STATE OF NORTH CAROLINA
DEPARTMENT OF TRANSPORTATION

Addendum No. 1
RE: Contract # C204039
WBS # 34243.3.2
STATE FUNDED
Polk County (I-4729A)
I-26/US-74/NC-108 Interchange Modifications in the Town Of Columbus

September 19, 2017 Letting

The following revisions have been made to the Roadway plans:

4-AUG-2017 08:20
J:\I-4729A\Roadway\XSCV\I-4729A_Rdy_xpl.dgn
$$$$USERNAME$$$$

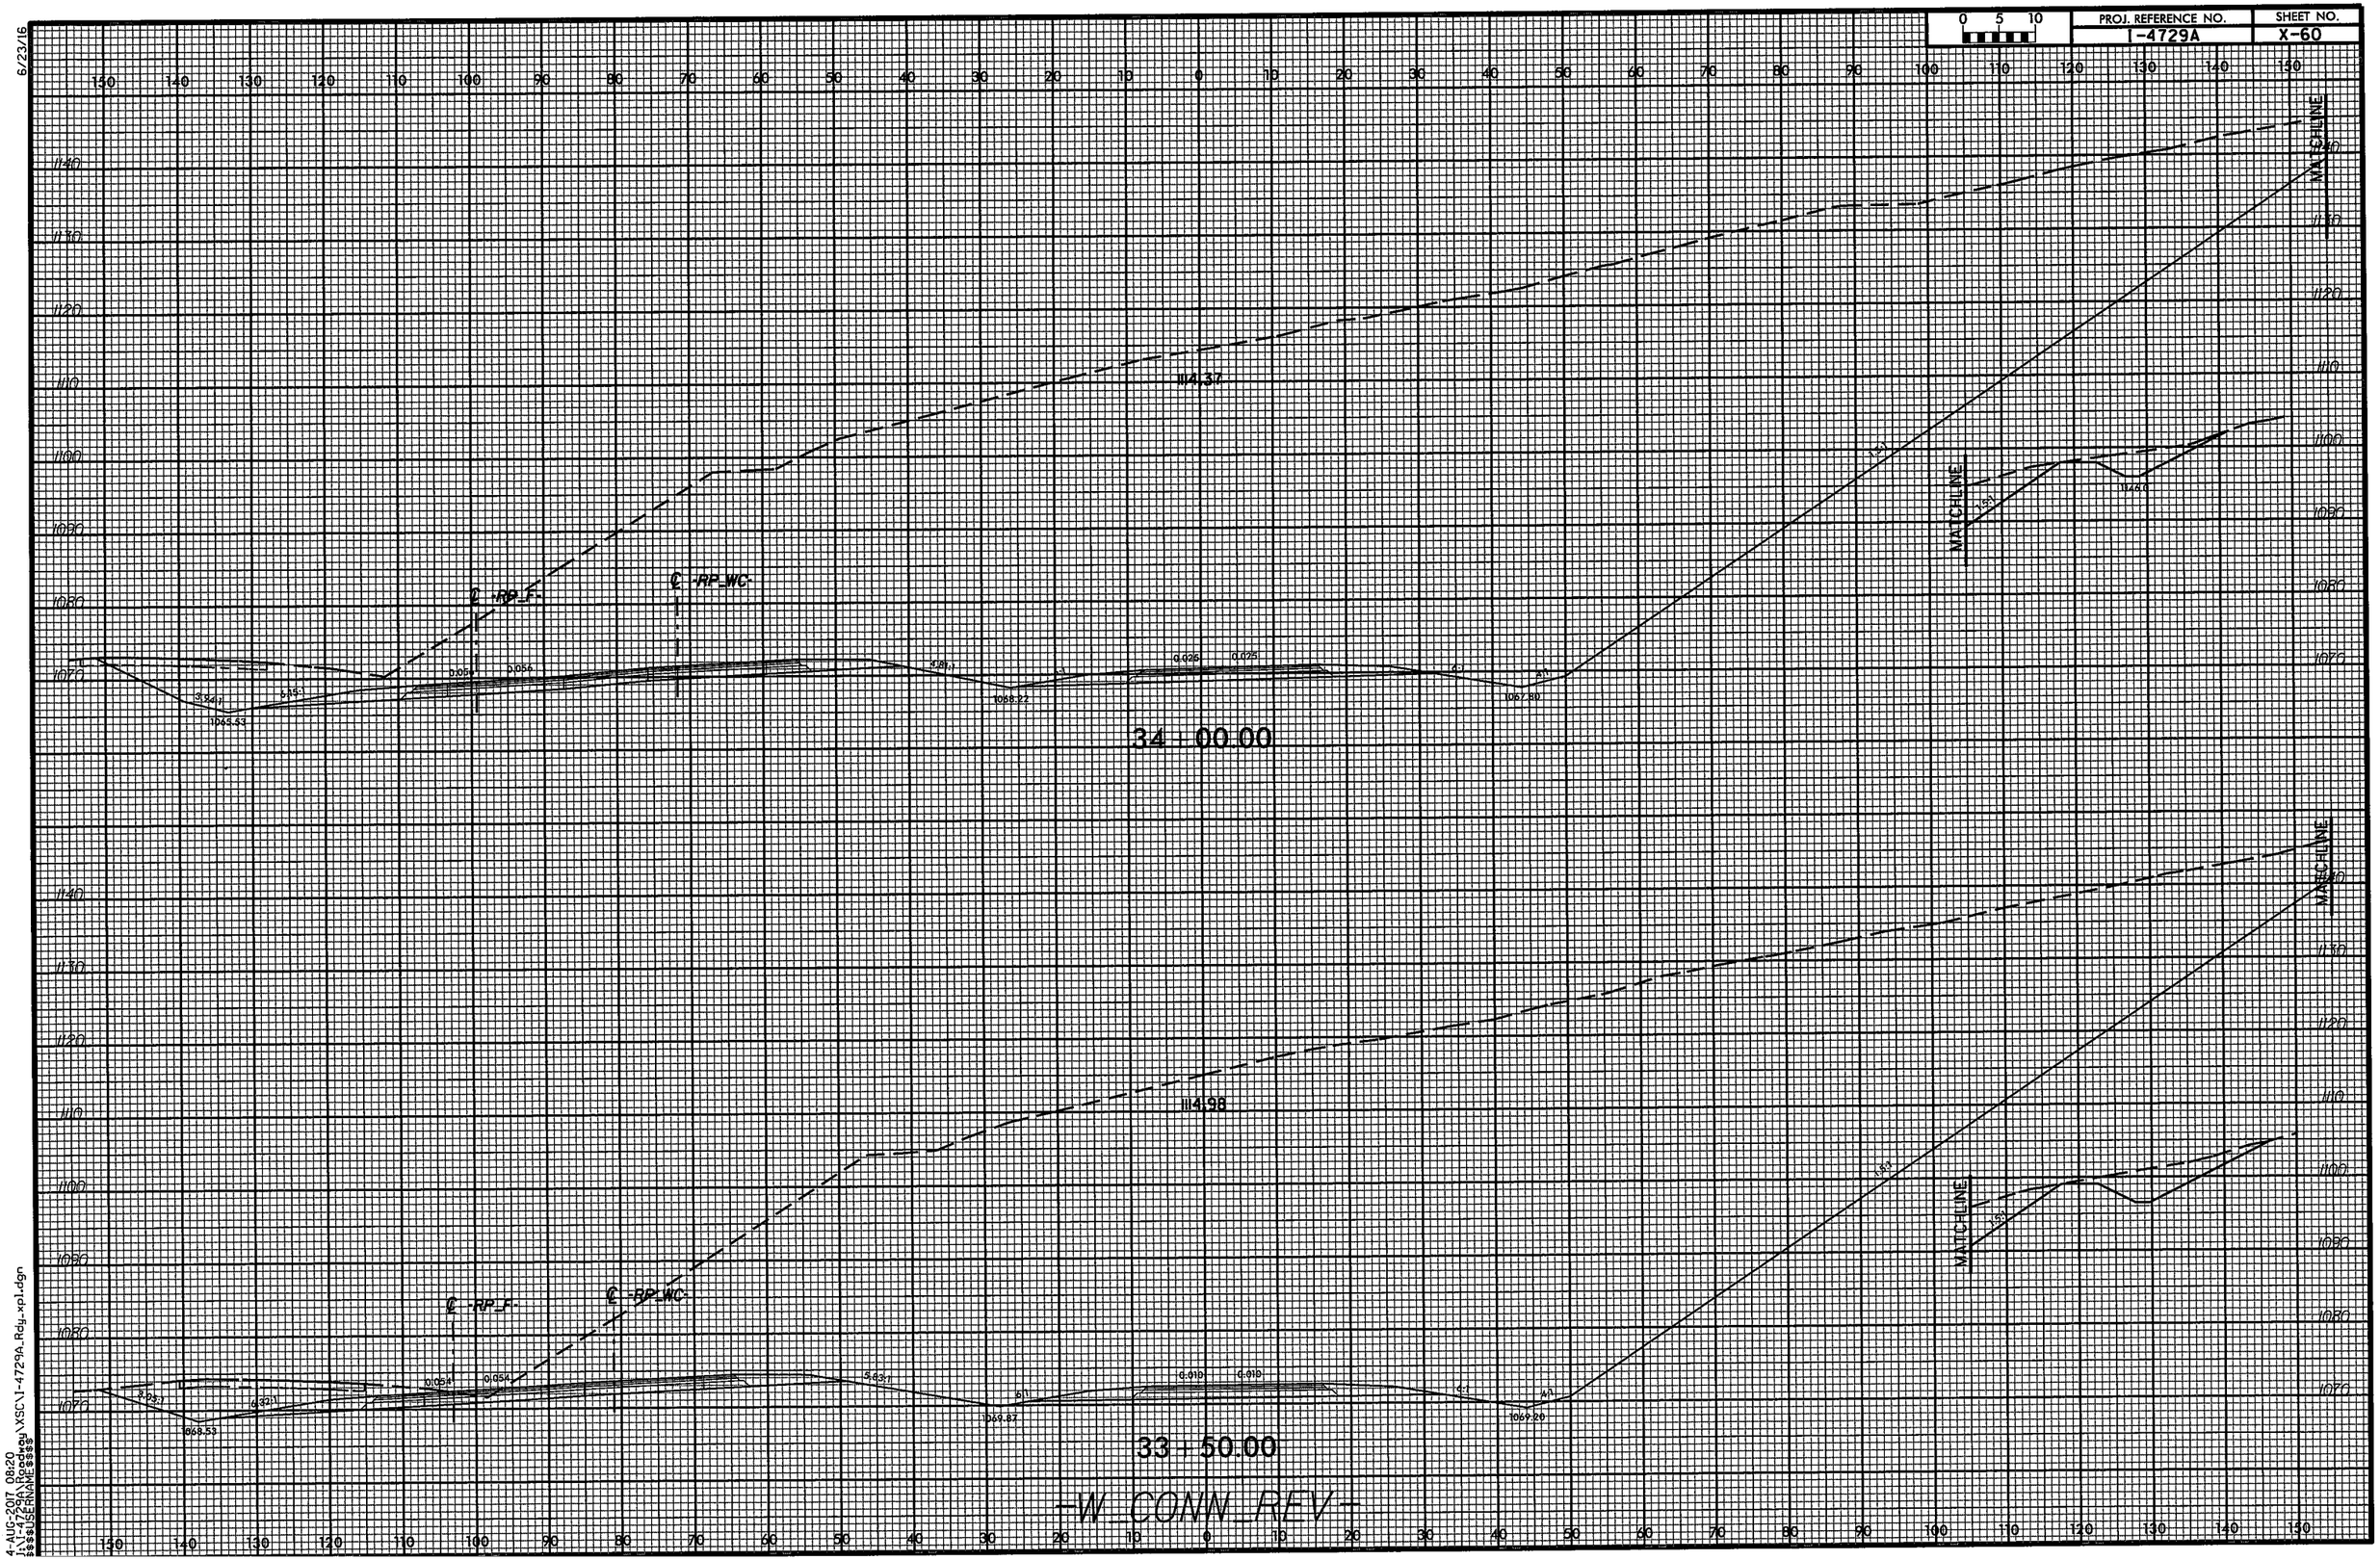
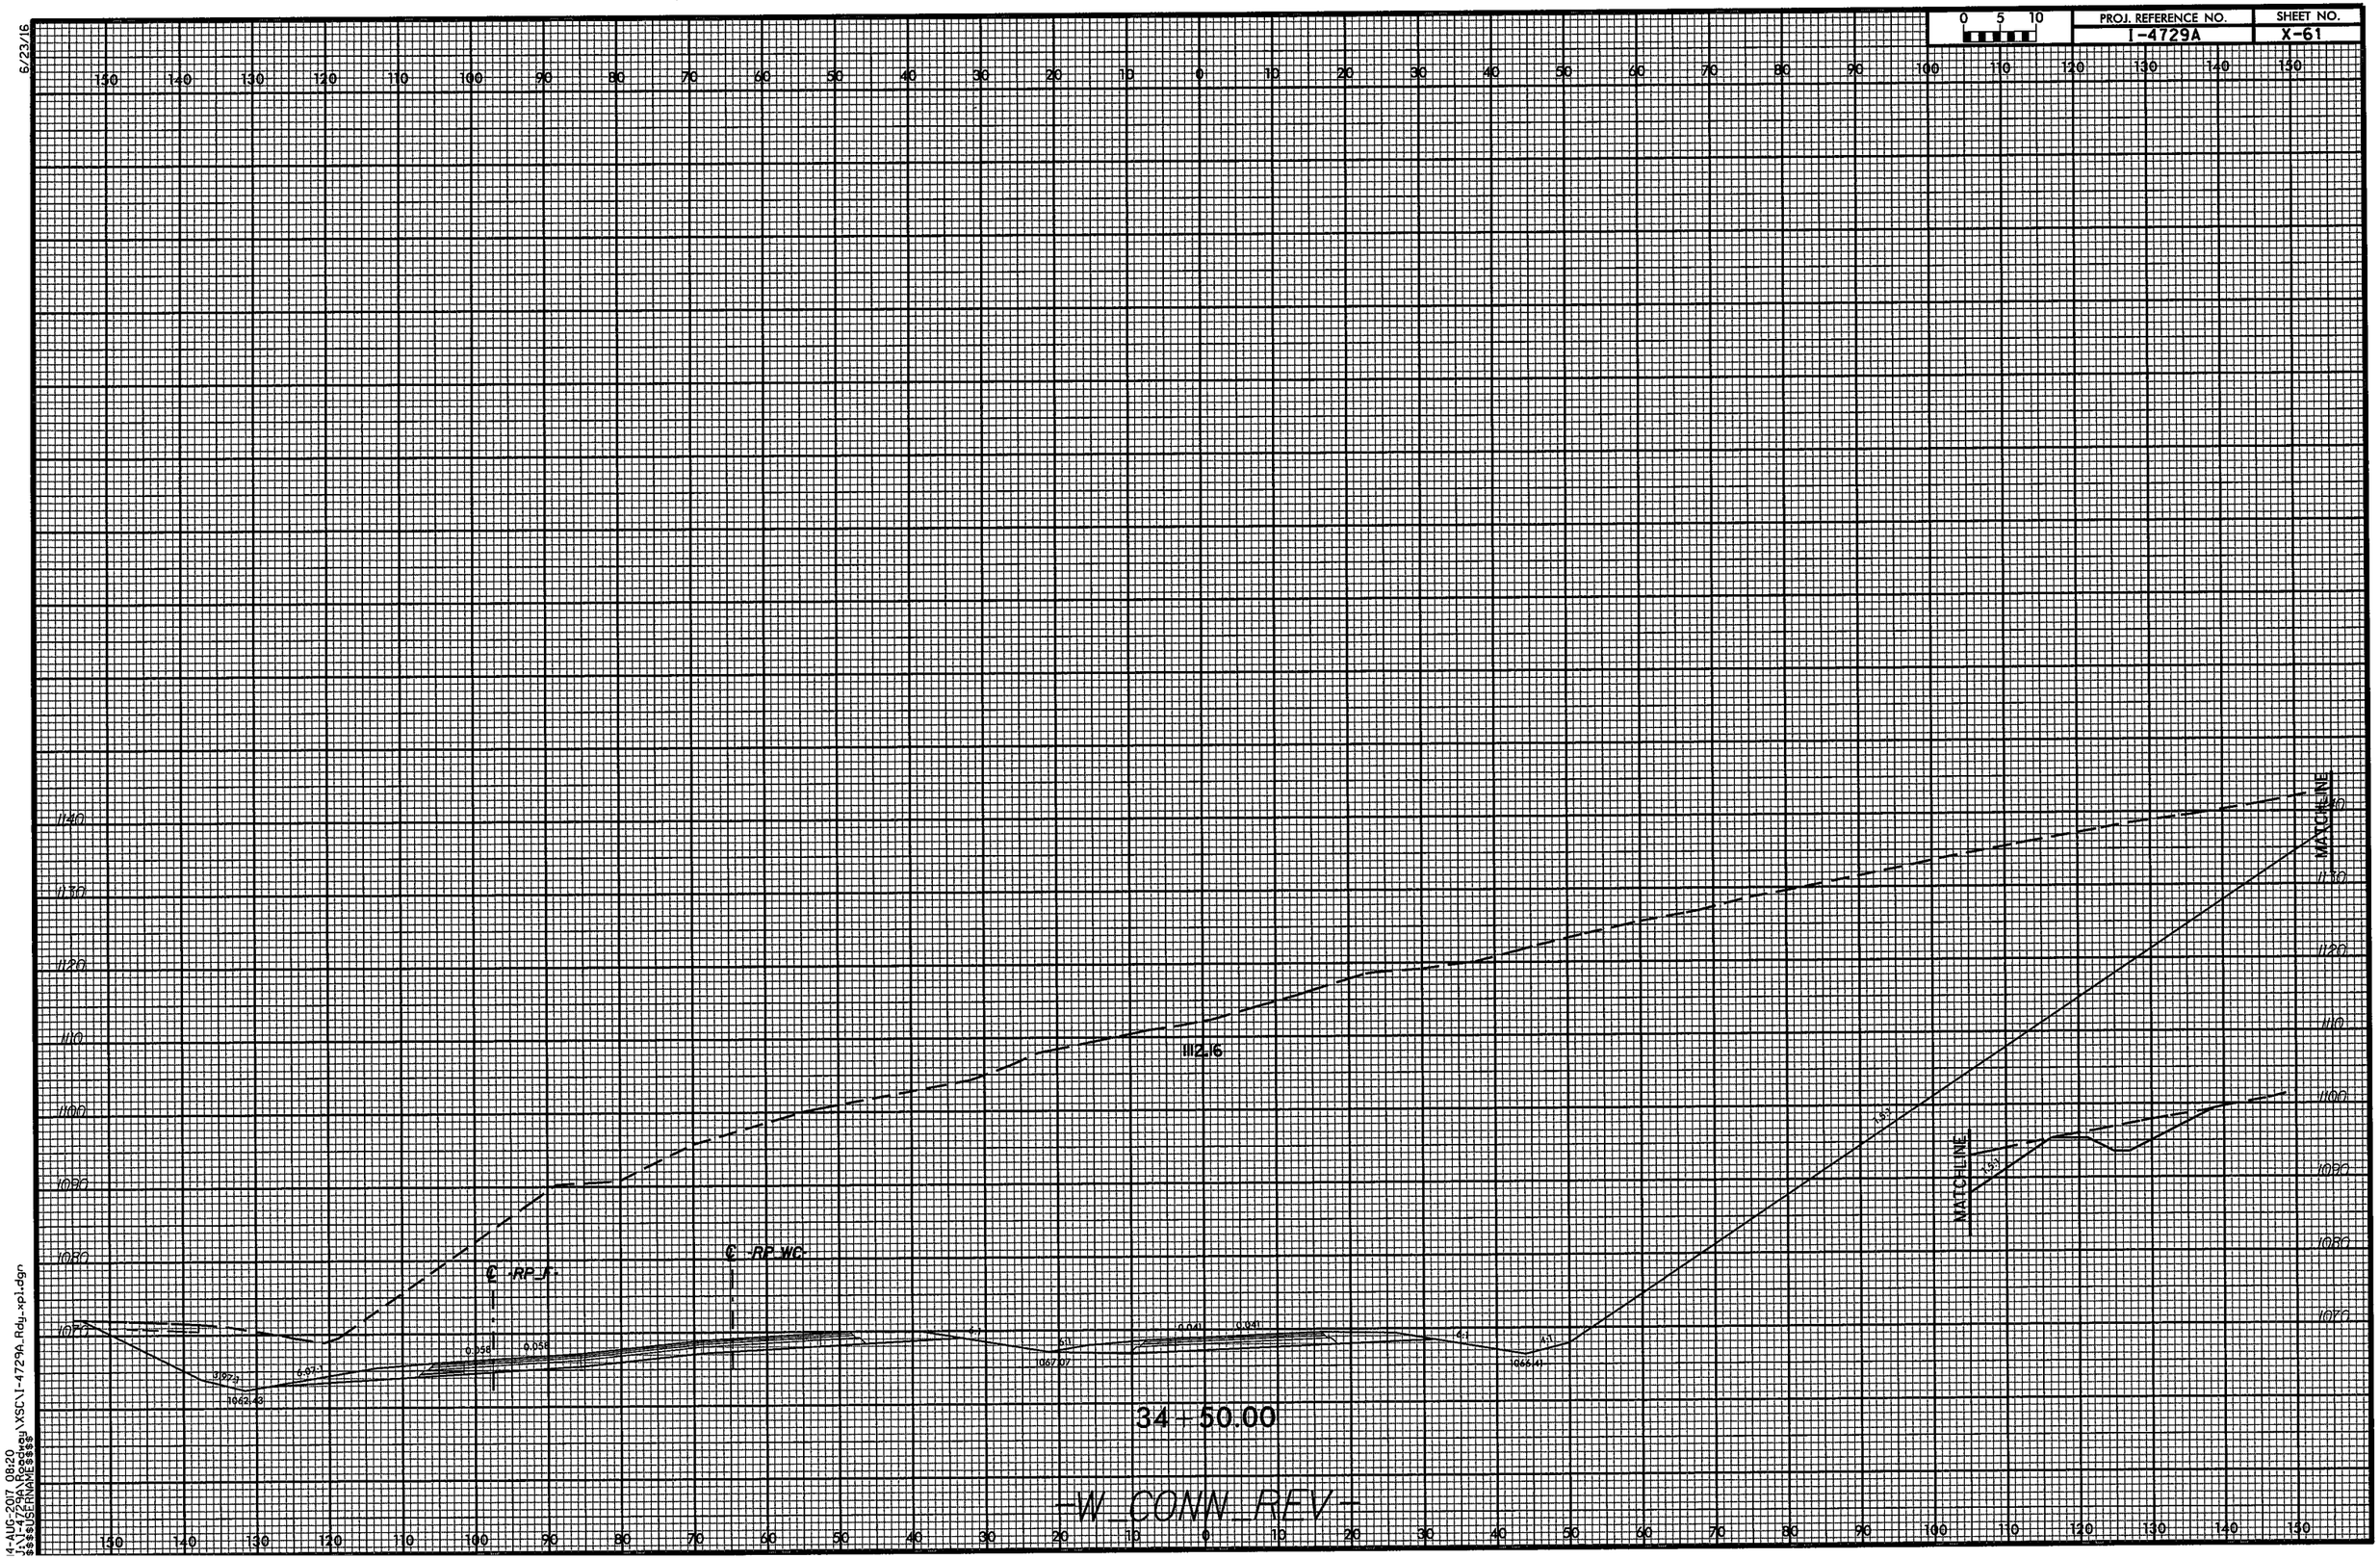
Sheet No.	Revisions
1A	Revised Index of Sheets to remove 2G-2 "Standard Embankment Monitoring Detail" and revise the number of" Drainage Summaries" sheets
2A-1, 2A-4 and 2A-5	Revised the Typical Sections for the change in mainline pavement widening design from ABC to Asphalt Base
3B-1	Revised 'Summary of Earthwork' to account for pavement widening design change
3D-1 thru 3D-4	Various drainage quantity changes as noted below
3G-1	Removed "Settlement Gauge Summary" and added note that Bridge Waiting Period only applies to Approach Slab construction
5	Revised to require Welded Steel Pipe by Trenchless method under the Interstate 26
X-1A thru X-87	Revised Cross-Sections to reflect the change in Earthwork due to the pavement design change
